LED drive current = 25mA

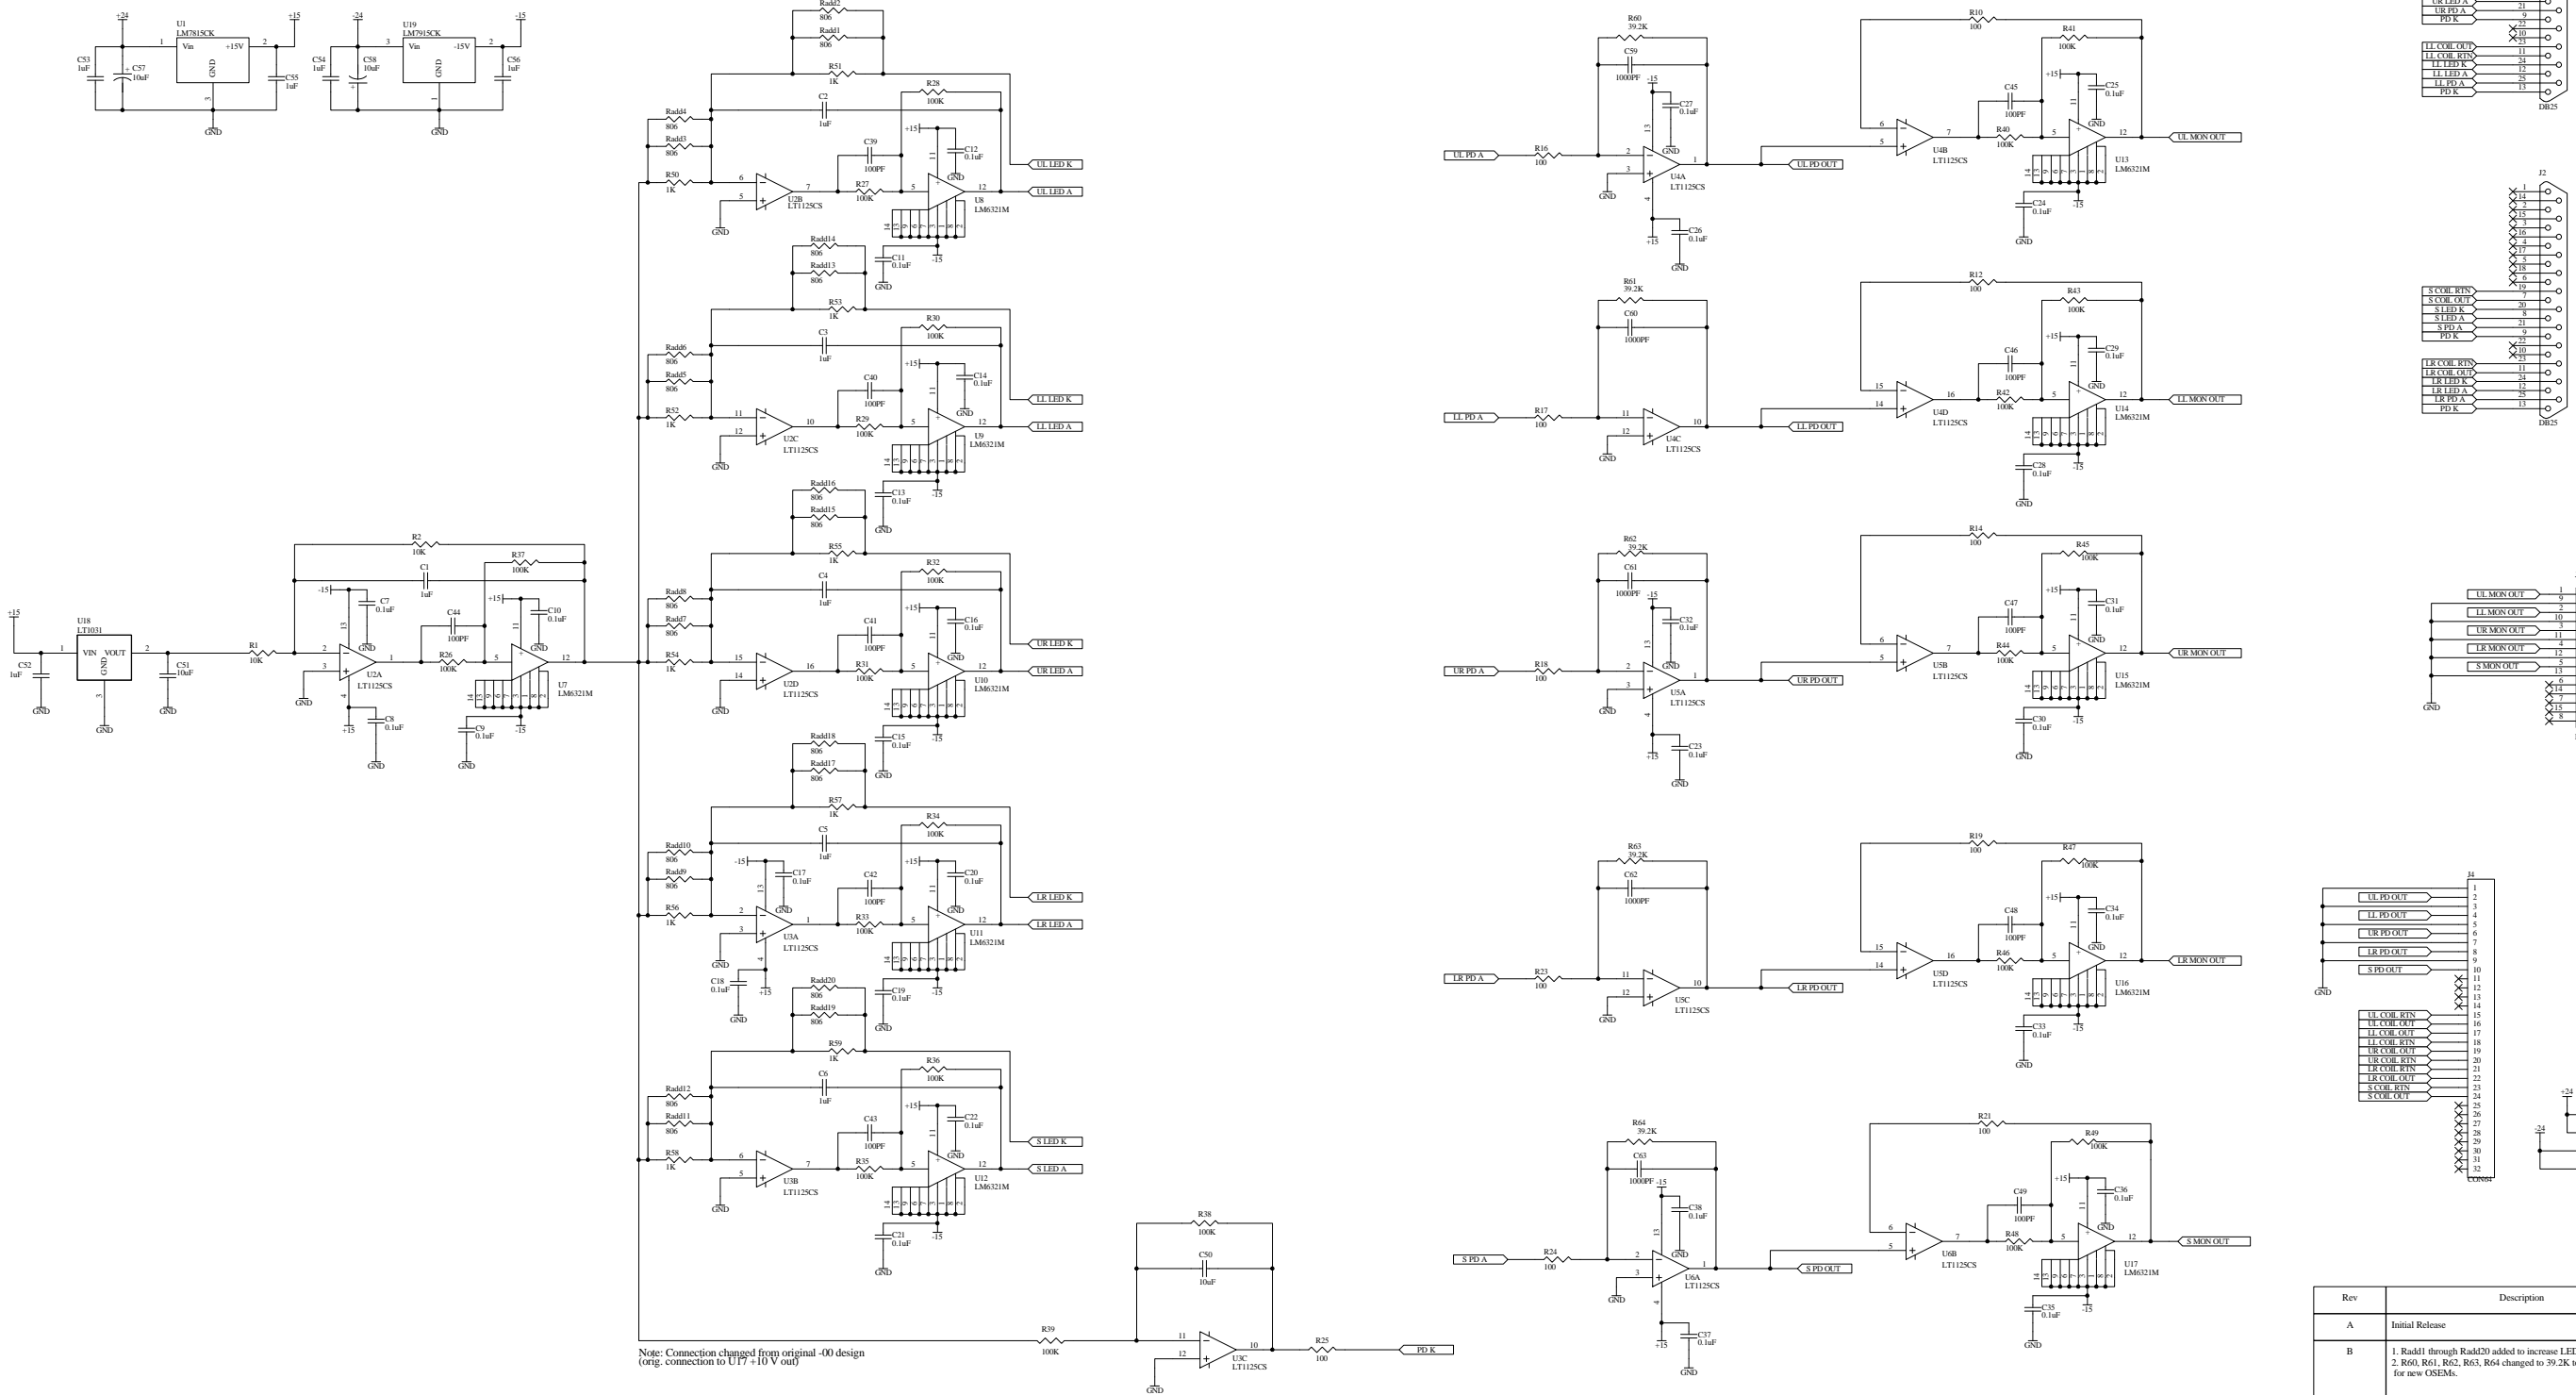
Rev	Description	Date
A	Initial Release	12/96
B	1. Radk1 through Radk20 added to increase LED drive to 25mA 2. R60, R61, R62, R63, R64 changed to 39.2K to increase EV gain for new OSEMs.	8/01
